DEVELOPMENT FACILITATION TEAM

Planning - Case Comments

Project Number: PR-2022-007805

Project Name: *Roses Southwest Papers – Crick Crossing between Watson SE and Hawking SE*

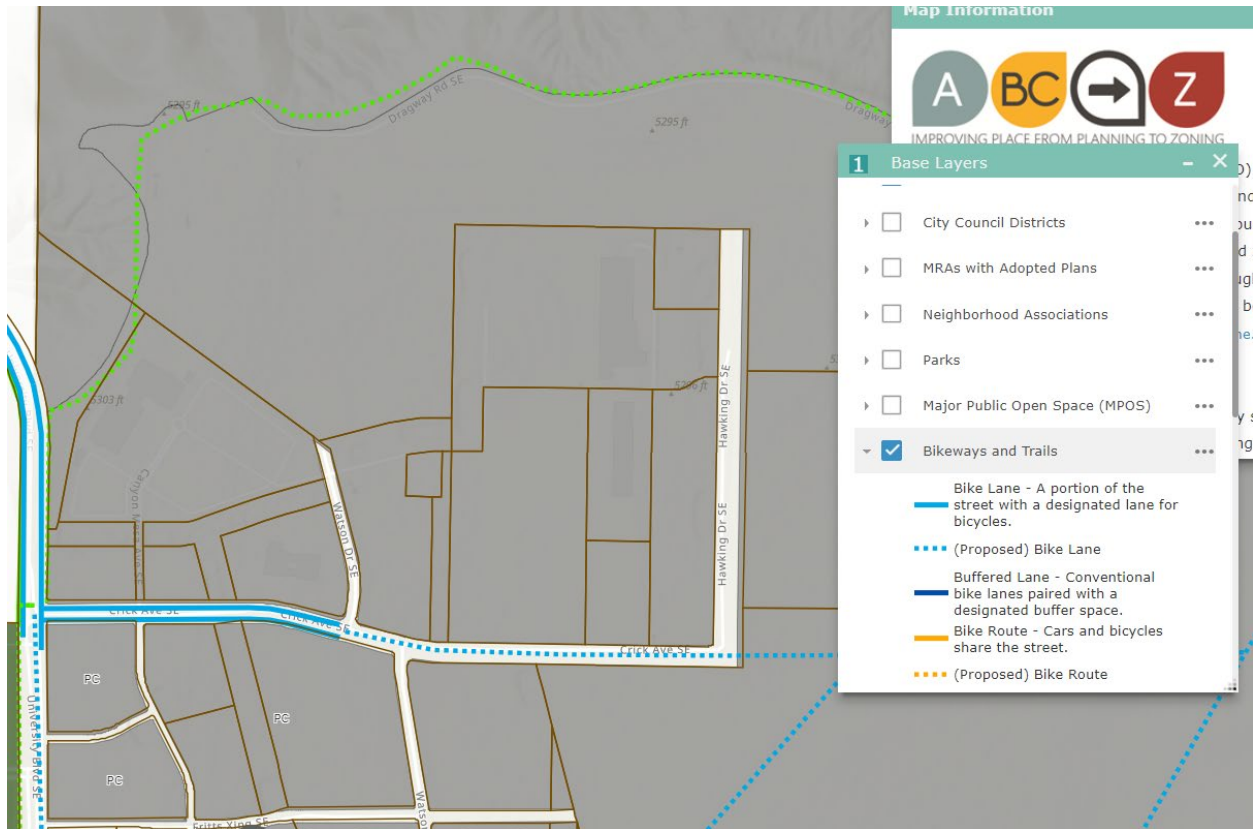
-Provide information regarding the drainage corridors that cross the subject property and how they are incorporated into the project and the neighboring lots.

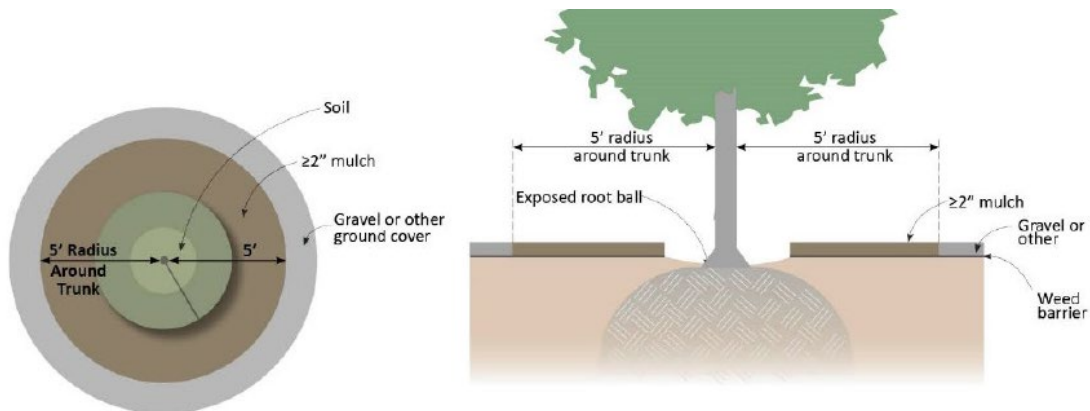
Calculations must be provided. On the plant legend please provide the quantity and coverage number for the plants.

Please refer to updated Landscaping Sheet.

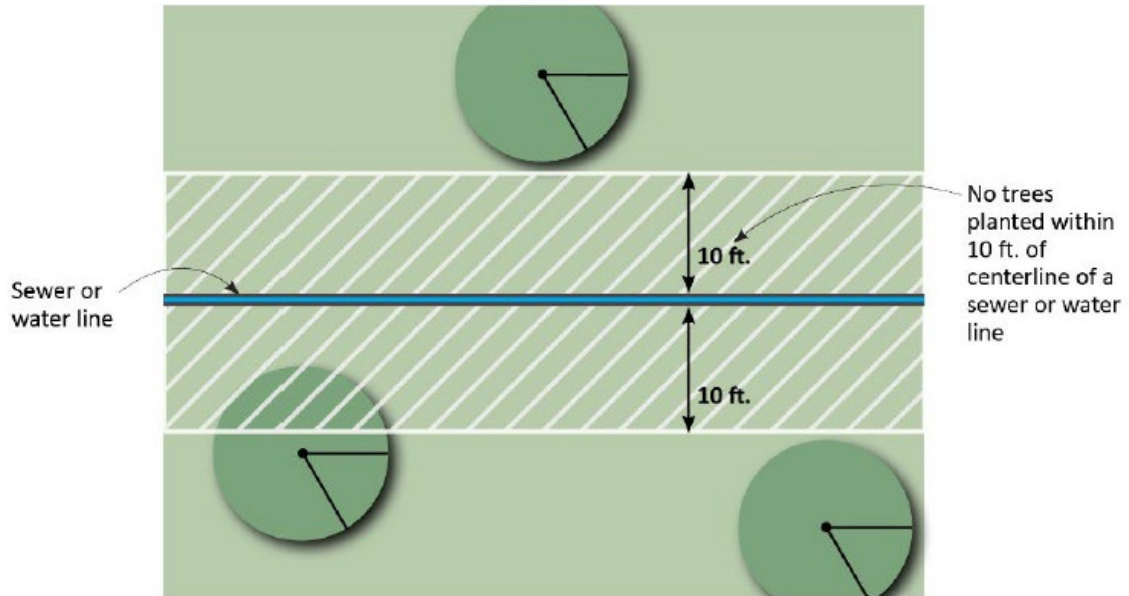
It appears that the irrigation design does not comply with this code. Please clarify or make adjustments.

Please refer to updated Landscaping and Irrigation Sheets.
